**Board Staff Interrogatories
2013 Electricity Distribution Rates
Peterborough Distribution Inc. ("PDI")
EB-2012-0173**

Exhibit 2: Rate Base

3-Staff-10. Ref: Exhibit 3,Tab 1, Schedule 3, Table 3-1

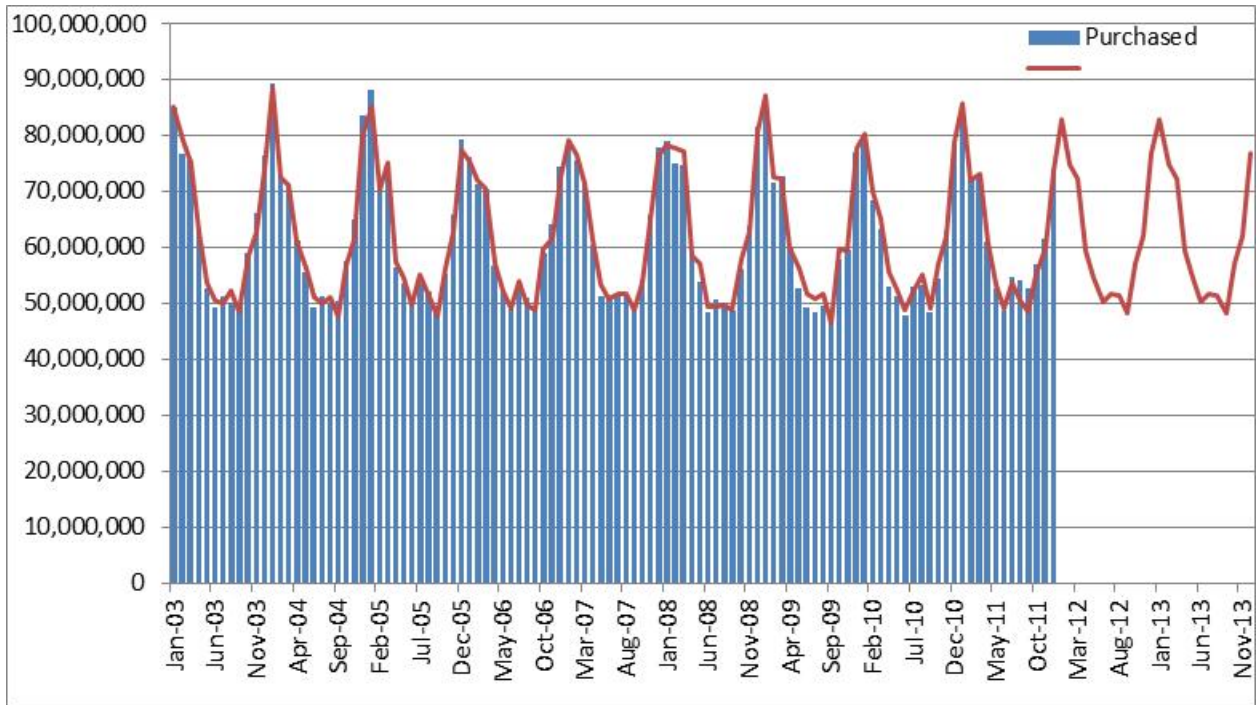
- a) Please provide Table 3-1 on the basis of the monthly actuals and forecasted amounts per the following (example) format. Please include forecasted values for 2012 and 2013 and actual values for 2012. If PDI has updated its load forecast, the provided chart should reflect the update.
